**NATIONAL BOARD  
INSPECTION CODE  
SUBGROUP ON HISTORICAL BOILERS**

***MINUTES***

*Meeting of July 16, 2012  
Columbus, Ohio*

Updated text and Diagram**S.2.13.9.2 WELDED REPAIR OF CRACKS IN UNSTAYED AREAS**

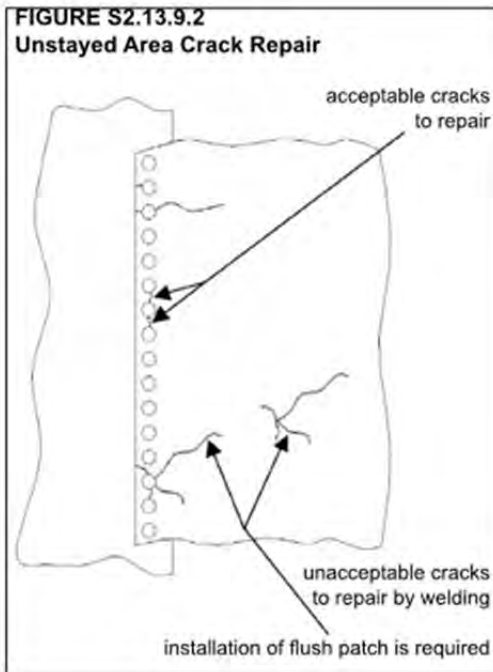
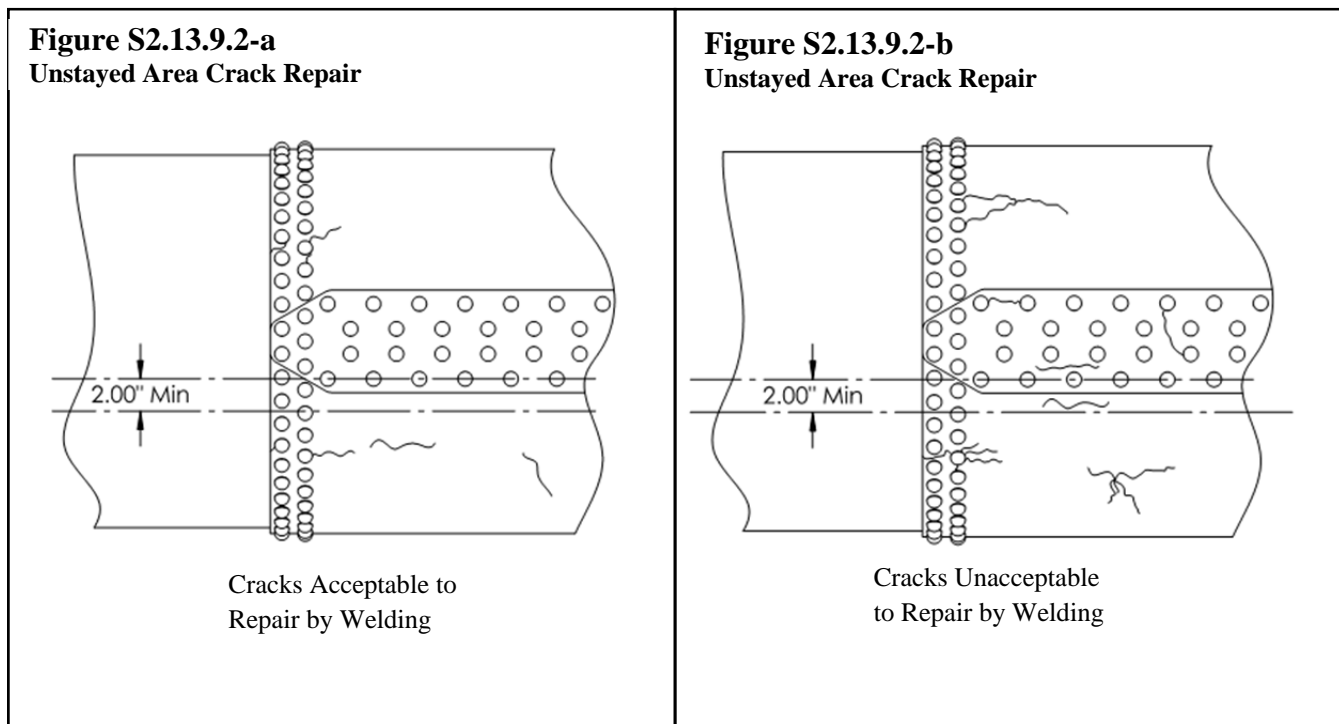
Proposal: Update figure S2.13.9.2 to show crack in non-riveted area, update text to fix a typo, move “See figure S.2.13.9.2” and change girth to circumferential.

1. Remove “See figure S.2.13.9.2” from a).
2. Correct Typo in b) should say Cracks in unstayed not Cracks in stayed
3. Change 8” requirement to insure that the repair is at least 2” from last row of rivets and that preheat is used. Text should be changed to “within 2in. (50mm) from the center line of the outer most row of rivets. Minimum 175 degree preheat shall be used.”
4. Add a reference to figure S2.13.9.2-a in c).
5. Add a reference to figure S2.13.9.2 –b in d).
6. Change girth to circumferential in d)
7. Use new figure S.2.13.9.2-a and S.13.9.2-b

Item # 7 Replace this with the Figure S2.13.9.2-a and Figure S2.13.9.2-b on page 3

- c) Cracks in unstayed areas may be repaired by welding, providing the cracks do not extend between rivet holes in a longitudinal seam or parallel to a longitudinal seam within 2in. (50mm) from the center line of the outer most row of rivets. Minimum 175 degree preheat shall be used. The complete repair must be radiographed and stress relieved. Alternative methods in lieu of Postweld Heat Treatment identified in NBIC Part 3, 2.5.3 may be used. (See NBIC Part 3, Figure S.2.13.9.2-a)

- d) Cracks radiating from a common point (star cracking) shall not be repaired; installation of a flush patch is required. Cracks radiating from a rivet hole in a circumferential seam may be repaired if the plate is not seriously damaged. (See NBIC Part 3, Figure S.2.13.9.2-b)

**S.2.13.13.1 Caulking Riveted Seams and Rivet Heads**

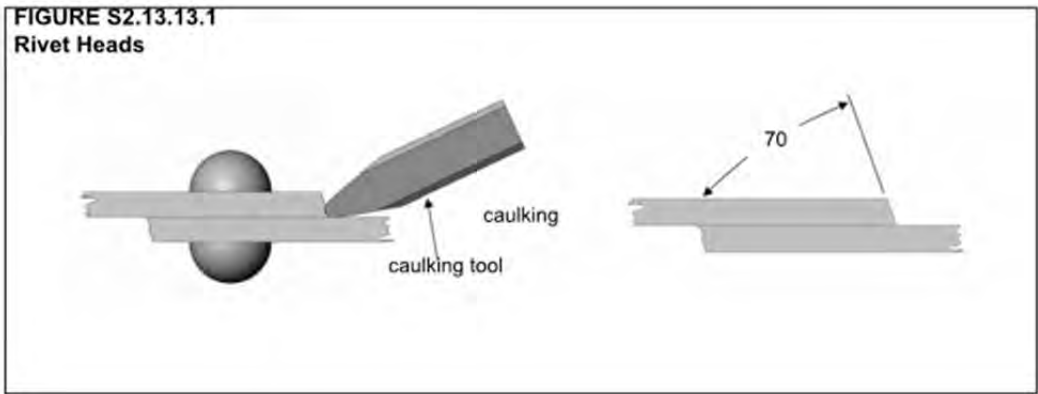
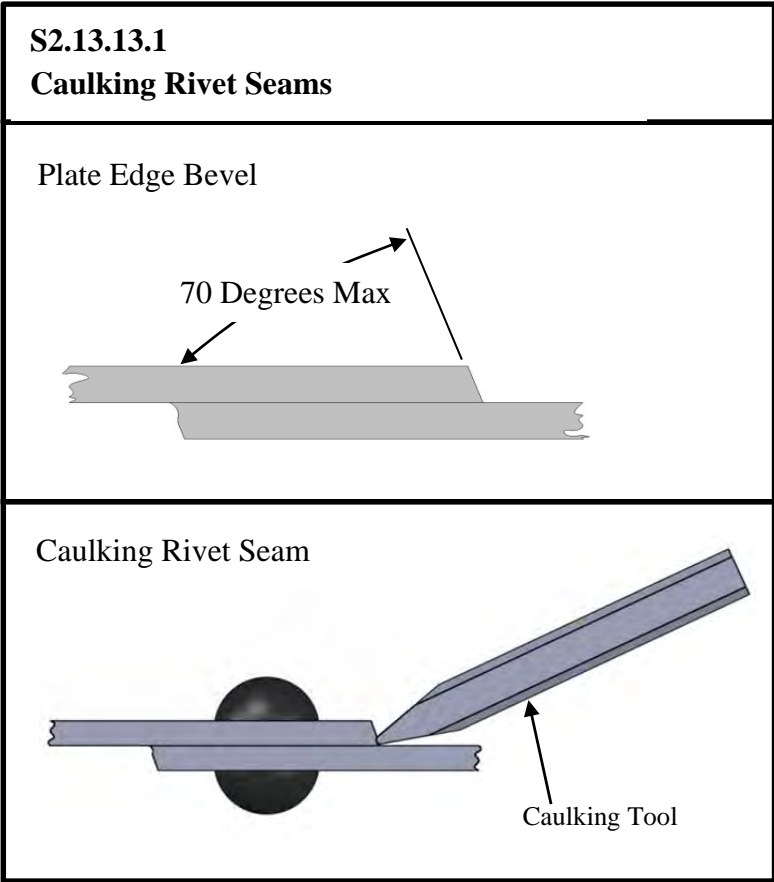
Proposal: Update figure S2.13.13.1 with proper title and update figure to show caulking rivet seams.

1. Update a) to say caulking tool instead of impact tool.
2. Current title calls out Rivet heads; however, figure shows caulking rivet seam. Figure title should be caulking rivet seams and show caulking rivet seams.

Item #2  
Replace this figure with the one update one on page 3

a) Caulking refers to the sealing of plate seams and rivet heads by driving the edge of one surface onto the other by use of a caulking tool.

### S2.13.9.1 – Weld Buildup of Wastage and Grooving in Unstayed Areas

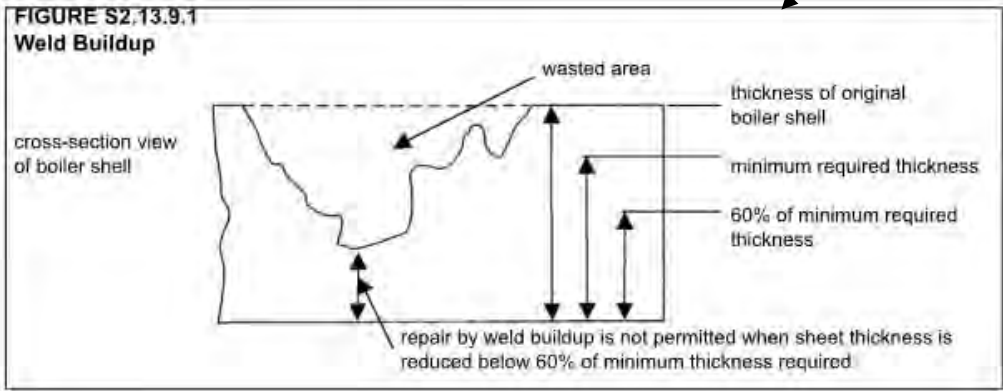
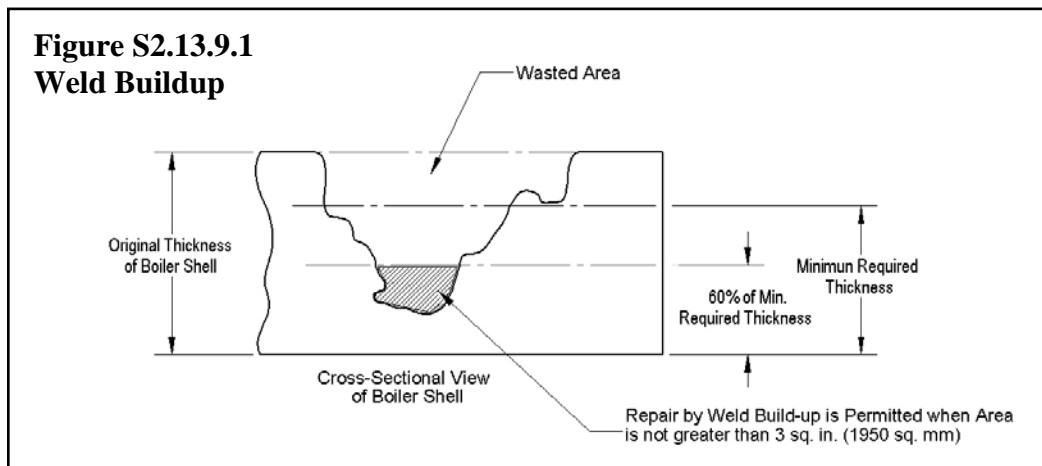
Proposal: Clarify the 60% minimum required thickness.

Explanation: An area of 3 square inches has been added to allow for the buildup of pits and grooving in smaller area's where the thickness is less than the 60% of minimum required.

1. Add “in an area exceeding 3 sq. in. (1,950 sq. mm).” to a)
2. Add “and have an area exceeding 3 sq. in. (1,950 sq. mm)” to b)
3. Update figure S2.13.9.

Item # 3 Replace this with the  
 Figure S2.13.9.1 on page 3

- a) Weld buildup shall not be used if the affected section of plate has wasted below 60% of the minimum required thickness per Part 2, Supplement 2 in an area exceeding 3 sq. in. (1,950 sq. mm). (See NBIC Part 3, Figure S2.13.9.1)

- b) Wasted sections that have wasted below 60% of the minimum required thickness and have an area exceeding 3 sq. in. (1,950 sq. mm), shall be repaired by installing a flush patch using full penetration welds.

Figure S2.10.2

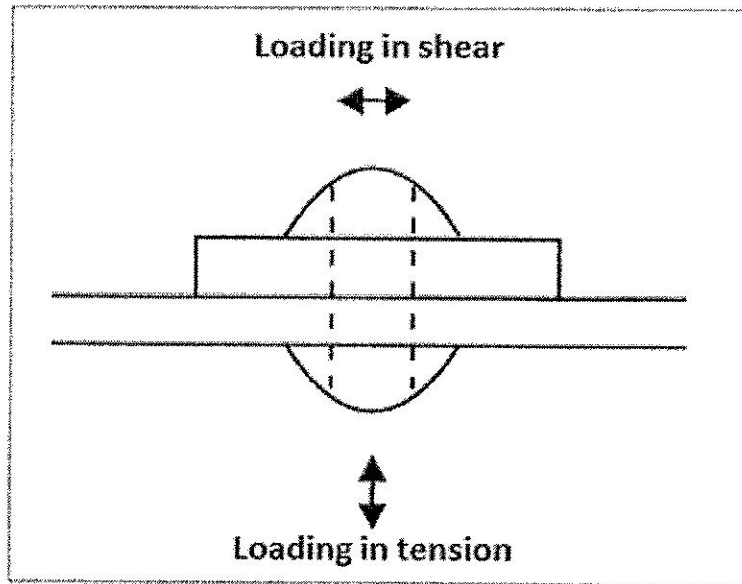
- a. Visually identify all connections containing rivets which show signs of significant corrosion.
- b. Categorize each connection as the type which loads the rivets in one of three possible modes (pure shear, pure tension, or combined shear and tension). Refer to Figure S2.10.2.

- ii. For rivets in pure tension, the amount of measured head deterioration shall not exceed 35% of its total head volume. Where rivets have countersunk heads, the head diameter must be equal or greater than 85% of original head diameter. Application of this value shall take into consideration the consistency and frequency of adjacent rivets showing excessive corrosion.

- iii. For connections subjected to combined shear and tension loads, the amount of measured head deterioration shall not exceed 60% of its total head volume. Where rivets have countersunk heads, the head diameter must be equal or greater than 75% of original head diameter. Application of this value shall take into consideration the consistency and frequency of adjacent rivets showing excessive corrosion.

**S2.13.10.1 WELD BUILDUP OF WASTAGE AND GROOVING IN STAYED AREAS**

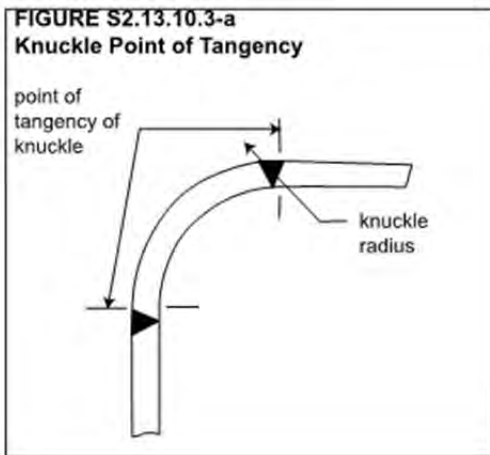
1. Remove “welding shall not cover rivet or stay bolt heads” due to redundancy with c)
2. Add the following text at the end of the requirement statement match the others in S2.13.10.2 & S2.13.10.3. “apply with the following additional requirements identified below.”
3. Remove typo “;and”
4. Remove d) completely. Figure has no reference to weld buildup. The figure is for Part 3, supplement 2, S2.13.10.3 and is referenced there.

Remove text

Requirements specified in NBIC Part 3, S2.13.9.1 shall be followed. ~~Welding shall not cover rivet or staybolt heads.~~

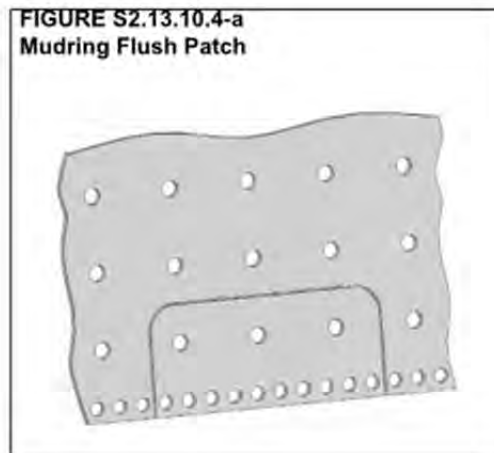
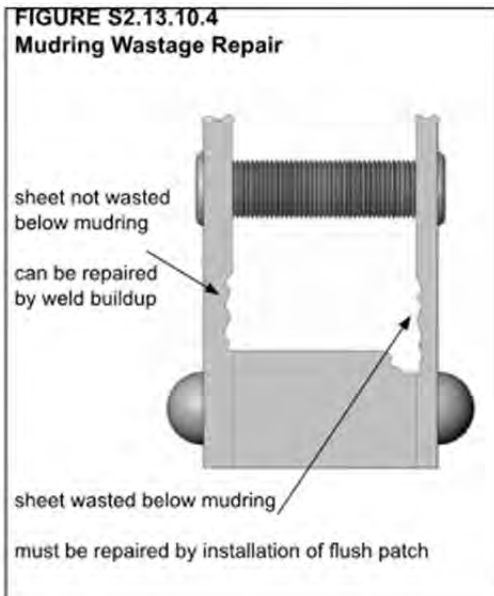
Explanation: Clarify the 60% minimum required thickness and make the description the same in all area's that figure S.2.13.9.1 reference.

1. Change text in b) to include the area exceeding 3 sq. in. (1,950 sq. mm).” Text would state “For mudrings of the locomotive style (See NBIC Part 3, Figure S2.13.10.4), weld buildup shall not be used if the affected section of plate has wasted below 60% of the minimum required thickness per Part 2, Supplement 2 in an area exceeding 3 sq. in. (1,950 sq. mm). (See NBIC Part 3, Figure S2.13.9.1) Repair by weld buildup cannot be used if the wastage extends below the waterside surface of the mudring or if the strength of the structure will be impaired. If extensive welding is required, the affected area shall be removed and replaced with a flush patch.”
2. Change text in c) to state “Wasted sections that have wasted below 60% of the minimum required thickness and have an area exceeding 3 sq. in. (1,950 sq. mm) shall be repaired by installing a flush patch using full penetration welds.”

- a) Mudrings of the Ogee style (knuckle) shall be repaired in accordance with NBIC Part 3, S2.13.11.
- b) For Mudrings of the locomotive style (see NBIC Part 3, Figure S2.13.10.4), grooved or wasted firebox sheets having greater than 60% of the minimum required thickness (see NBIC Part 3, Figure S2.13.9.1) remaining may be repaired by weld buildup provided the wastage does not extend below the waterside surface of the mudring and the strength of the structure will not be impaired. If extensive welding is required, the affected area shall be removed and replaced with a flush patch.

**FIGURE S2.13.14.2**  
**Repair of Handhole Opening**

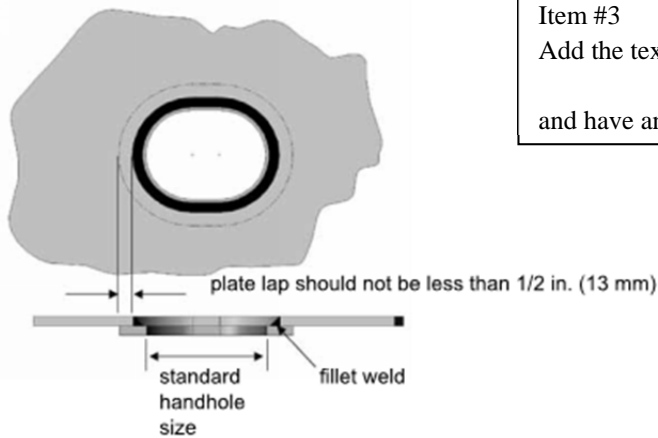
1. Add “in an area exceeding 3 sq. in. (1,950 sq. mm).” to a)
2. Move Text “Weld buildup of wasted areas shall not exceed 100 sq. in. (65,000 sq. mm).” to item d) to match other area's of the NBIC repair section.
3. Add “and have an area exceeding 3 sq. in. (1,950 sq. mm)” to c)

Item #3  
 Add the text below:  
 and have an area exceeding 3 sq. in. (1,950 sq. mm).

- a) Weld buildup shall not be used if the affected section of plate has wasted below 60% of the minimum required thickness per Part 2, Supplement 2 in an area exceeding 3 sq. in. (1,950 sq. mm). (See NBIC Part 3, Figure S2.13.9.1)
- b) Weld buildup is to replace material that has been lost due to wastage and grooving, and is not to replace thickness on the opposite side of the sheet. Weld buildup must be applied to the side of the sheet that is wasted or grooved.
- c) Wasted sections that have wasted below 60% of the minimum required thickness and have an area exceeding 3 sq. in. (1,950 sq. mm), shall be repaired by installing a flush patch using full penetration welds.
- d) Weld buildup of wasted areas shall not exceed 100 sq. in. (65,000 sq. mm).
